DETAILED ACTION

This is a final Office action. Claims 1-7, 9, 11, 14 and 17-20 are pending and examined below. Claims 8, 10, 12, 13, 15 and 16 have been cancelled.

Figure 5 from Stark

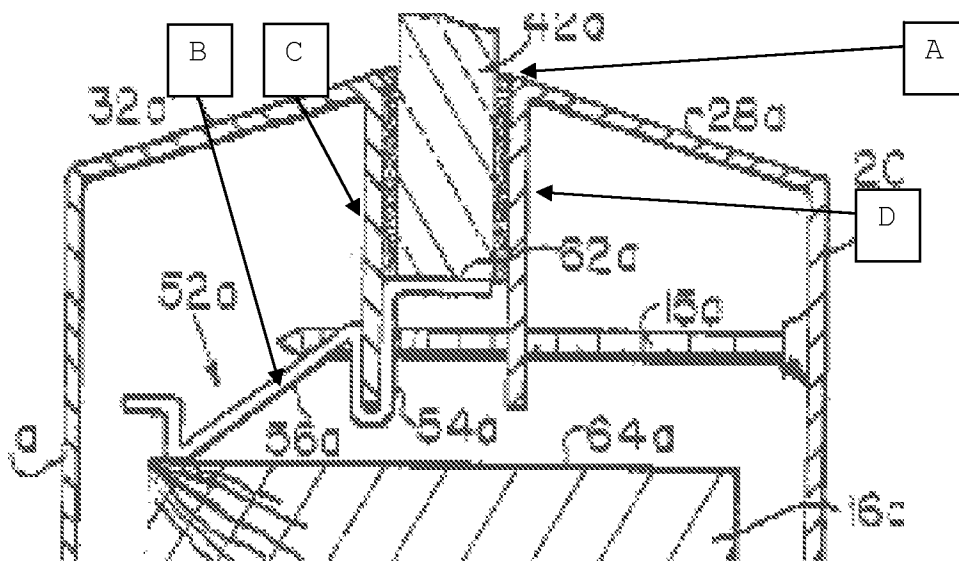
Claim 1: Stark discloses a window panel comprising first and second flange units (Fig. 5: 22a, 20a, respectively) each

comprising a preassembled rectangular frame (Fig. 1, generally), sash elements (32a, 28a, "C" and "D" from attached Fig. 5 below respectively) that extend into the opening to capture a transparent pane (42a), at least one retention member (52a) attached to the first flange unit and extending into the opening, the member is beyond a position of the pane with respect to the first flange unit when positioned between the sash elements (it is beyond a position of the pane in the direction between the pane and the frame opening 62a) to grip a sill surface (64a) to retain the first flange unit (22a) and the sash element in position for assembly, the retention member has an end (see "A" from attached Fig. 6 from Stark, below) unobstructed by the first flange unit when the unit is in position for assembly, and at least one fastener (15a) adapted to draw the first and second flanges and the sash elements together against the pane, the sash elements include flanges extending generally parallel ("C" and "D") to the pane when captured therebetween, the ends of the flanges can flex inwardly spring biased sharp edge portions (see "B" from attached Fig. 5 from Stark, below, and the edge portions are spring-biased via fastener, 15), and the elements include flanges (20a) extending generally parallel to the pane are spring biased via fastener (15a) in contact with the pane and the edge portion would embed

in the pane when the pane is in a semi-molten state. The language "wherein said sharp edge...semi-molten in fire" lines 13 and 14 are steps that relate to a desired result and the examiner contends that as a glass pane becomes molten, it will inherently soften which would result in virtually anything imbedding in the pane if a force (such as a spring bias against the sharp edge) were applied to it. Regarding the limitation "preassembled", the limitations are drawn to method steps and only the final product, the apparatus, is provided patentable weight. The embodiment of Figure 5 from Stark does not disclose a spike as claimed, but the embodiment in Fig. 6 discloses a spike portion (65, 66) that affixes the first end to a core material of a sill surface (as shown), and the spike can be driven into the core material by impact of a hammer if desired. It would have been obvious at the time the invention was made to a person having ordinary skill in the art to use the member in Fig. 6 with the member in Fig. 5 as a matter of functional equivalence that would perform equally as well.

In addition, while Stark discloses frame units that are connected, it does not disclose the units are connected by welds. La See discloses a window unit for a door with frame members connected by welds (48: col. 4, lines 60-68). It would have been obvious at the time the invention was made to a person

Claim 7: the opening is rectangular (Fig. 1) having four sill surfaces and the vision panel has four retention members (see Fig. 4, generally), attached indirectly to the first flange unit and extending into the opening to grip all four sill surfaces.

Claim 9: a surface of the retention member (62a) supports edges of the pane.

Figure 4 from Plym

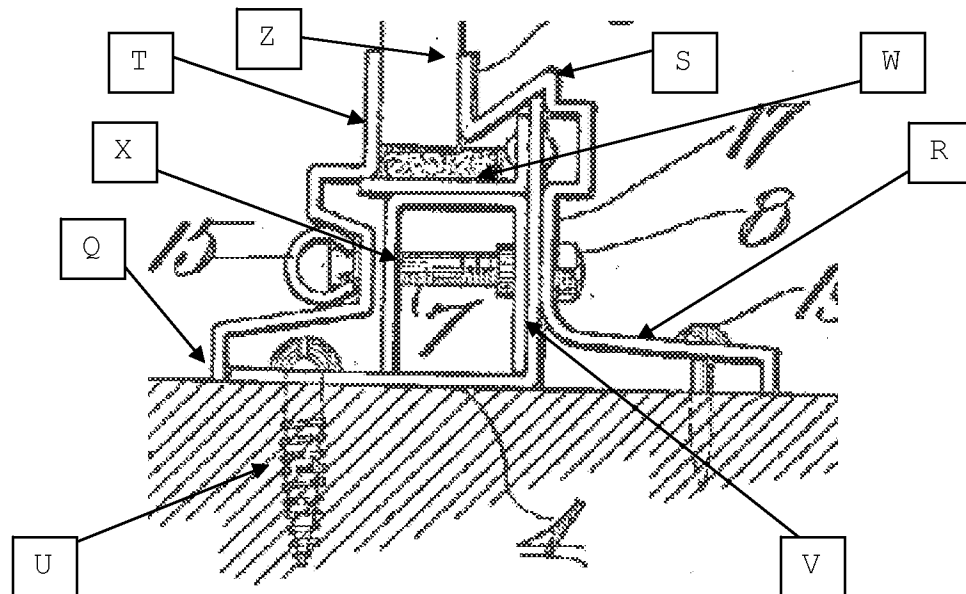
Claim 1: Plym discloses a vision panel for assembly in an opening (as shown) a first and second flange unit (see "Q" and "R" from attached Fig. 4 from Plym below) sash elements ("S" and "T" below) that extend into the opening from the flange units to capture the pane, a retention member (4) attached to the first flange unit that extends beyond a position of the transparent pane with respect to the first flange unit when positioned between the sash elements, the retention member has an end (proximate 4) unobstructed by the first flange unit when the first flange unit is in position for assembly, a spike ("U" below) positioned on the first end to affix the first end to a core material (1) a fastener (7) adapted to draw the flange units and sash elements together against the pane (10) and the sash elements include flanges (proximate actual portion 18) extending generally parallel to the pane, the ends are flexible and provide spring-biased sharp edge portions (e.g. corner portion proximate 18 is a sharp edge) in contact with the pane

and the portion would embed in the pane if the pane became semi-molten in a fire.

While Plym discloses a spike ("U") it does not disclose the spike is positioned to be driven by an impact of a hammer, as it is a screw. Petta discloses that it is known in the art to attach frame members to an opening using nails (Col. 5, lines 37-45). It would have been obvious at the time the invention was made to a person having ordinary skill in the art to use a nail in place of the screw, as the two are functionally equivalent and would perform equally as well.

Claim 3: the fastener (7) is a threaded fastener, and the second flange unit includes a hole (as shown) for receiving the threaded fastener and the retention member includes a socket (8) that can receive an end of the threaded fastener as it passed through the hole.

Claim 4: the socket is attached to the retention member by a spring element (it is indirectly attached via member "V" above) allowing movement of the socket toward the second flange unit against a spring force bias.

Claim 5: the spring element is a cantilevered tab (as shown) extending across an axis of the threaded fastener to flex with increased engagement of the threaded fastener.

Claim 6: the fastener has a non-threaded section (as shown) which would limit an engagement of the threaded fastener with the socket.

frame the opening, sash elements ("S", "T") that extend into the opening and hold a transparent pane therebetween, a spring member (4) attached to the first flange and extending into the opening to support a socket ("X") on a cantilevered tab (as shown), a fastener (7) engages the second flange unit and the socket to draw the first and second flange units and sash elements together against the pane, the fastener includes a head and shank (as shown) and the shank includes a non-threaded section (as shown) between the head and threaded section, the non-threaded section limits a depth of engagement, and a portion of the socket is drawn over a non-threaded section to disengage with the fastener as the threaded fastener is advanced, and the limited depth of engagement provides a predetermined compressive force. While Plym discloses a system with a socket, it does not disclose that the socket is threaded. It would have been obvious at the time the invention was made to a person having ordinary skill in the art to have the socket threaded to facilitate the connection of the threaded portion of the bolt with the framing member.

Claim 19: the sash elements include inwardly biased sharp edge portions (see "Z" above as the corner portion is inwardly biased; the forces created by the frame and threaded bolt, as the members are drawn together, results in the members that are inwardly biased; in other words if the pane were not present, the members would be drawn closer to each other, which makes

Claim 20: as shown, and upper surface of the retention ("W" above) member supports the bottom of the transparent panel (as shown).
